ADDENDUM NO. 1
to
PLANS and SPECIFICATIONS
for

Medina River Sewer Outfall, Segment 1
SAWS Job No. 10-2501

Issue Date: July 23, 2010

**SAN ANTONIO WATER SYSTEM
MEDINA RIVER SEWER OUTFALL, SEGMENT 1
SAWS PROJECT # 10-2501
ADDENDUM NO. 1**

REVISIONS:
 05-11-2010 PACKAGE*
 CHANGED BID STATION TO
 REVERSED END STATION TO
 STA. 306+14.19
 CARA C. TACKETT
 89491
 07/02/10

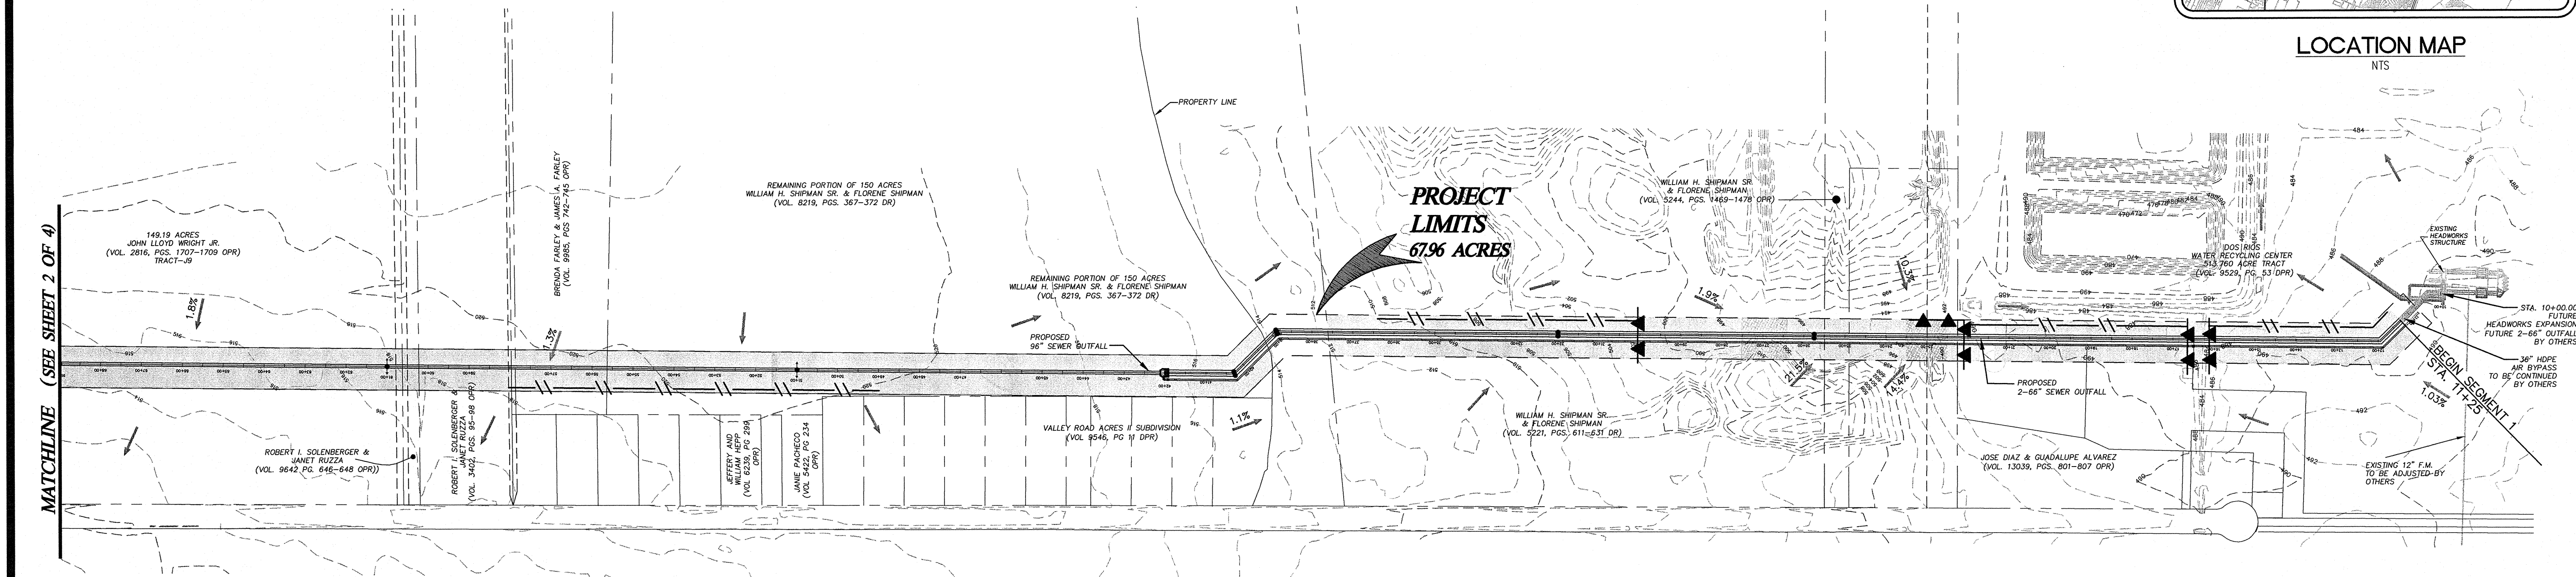
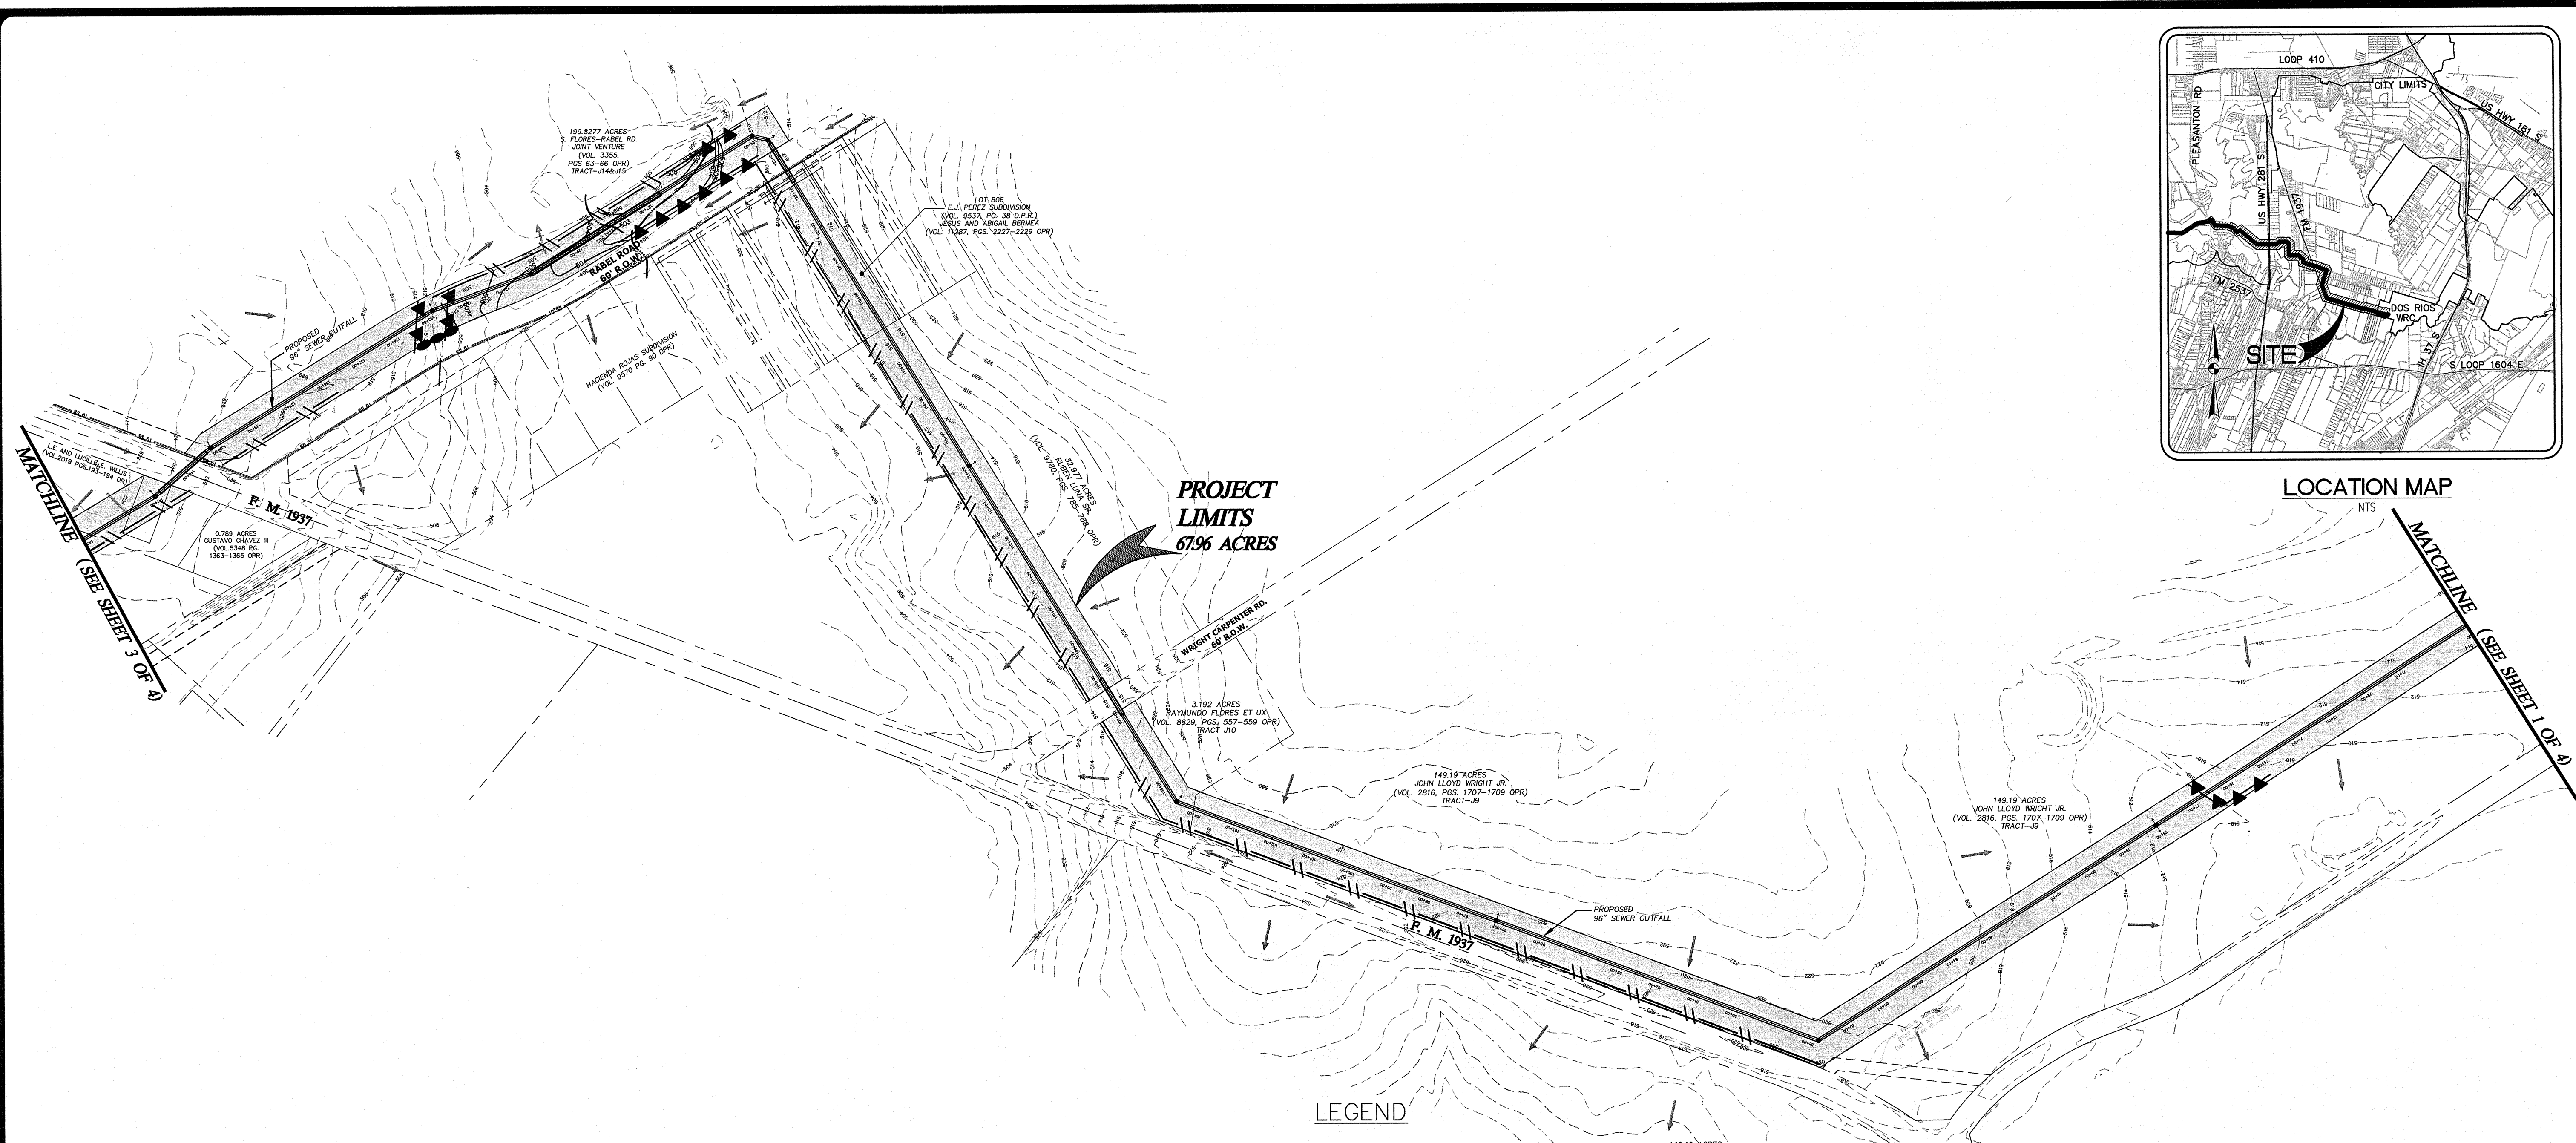
REVISIONS:
05-11-2010 CHANGED "BD PACKAGE"
CHANGED "BD PACKAGE"
REVISED END STATION TO STA. 306+14.19
